Access Compliance Report

Public Rights-of-Way

(Curb Ramps)

Intersection ID: 46819	Main Street: CLAUDE_FREEMAN_DR	Cross Street: AZALEA_HILLS_DR	Location: NE
ADA ID: F47915A603CA	Ramp Type: BlendTrans1	Initial Pass/Fail: Fail	Overall Compliance: No
Severity Score: 8.75			
Codes/Mitigation Info/Possible Solution		Field Measurements/Component Compliance

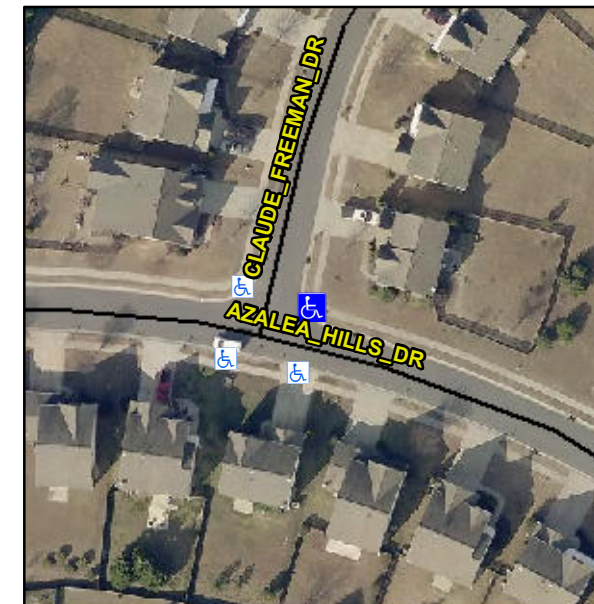
Compliance	Description	Data	Compliance	Description	Data
N/A	Ramp Length (in)	47.0	Yes	BlendTrans Slope (%)	4.1
No	Ramp Width (in)	46.0	Yes	BlendTrans XSlope (%)	0.7
N/A	Flare Type LT	N/A	N/A	Flare Type RT	N/A
N/A	Flare Slope LT (%)	N/A	N/A	Flare Slope RT (%)	N/A
N/A	Flare Traversable LT?	N/A	N/A	Flare Traversable RT?	N/A
N/A	Landing Length (in)	N/A	N/A	DWS Provided?	N/A
N/A	Landing Width (in)	N/A	N/A	DWS Contrast?	N/A
N/A	Landing Slope (%)	N/A	N/A	DWS Length (in)	N/A
N/A	Landing X Slope (%)	N/A	N/A	DWS Full Width?	N/A
N/A	Landing Curb? (Y/N)	N/A	N/A	DWS Offset (in)	N/A
N/A	Shared Landing?	N/A			
N/A	Gutter Ponding?	N/A	N/A	Gutter Slope (%)	N/A
N/A	Gutter Lip Ht (in)	N/A	N/A	Gutter X Slope (%)	N/A
N/A	Painted X Walk1?	No	N/A	Painted X Walk2?	No
	X Walk 1 Direction	To W		X Walk 2 Direction	To S
	X Walk 1 Width (in)	N/A		X Walk 2 Width (in)	N/A
	X Walk 1 Slope (%)	1.3		X Walk 2 Slope (%)	0.7
	X Walk 1 X Slope (%)	0.2		X Walk 2 X Slope (%)	1.3

Remove & Replace Curb Ramp With Two New Directional Ramps or Equivalent.

R304.5.1
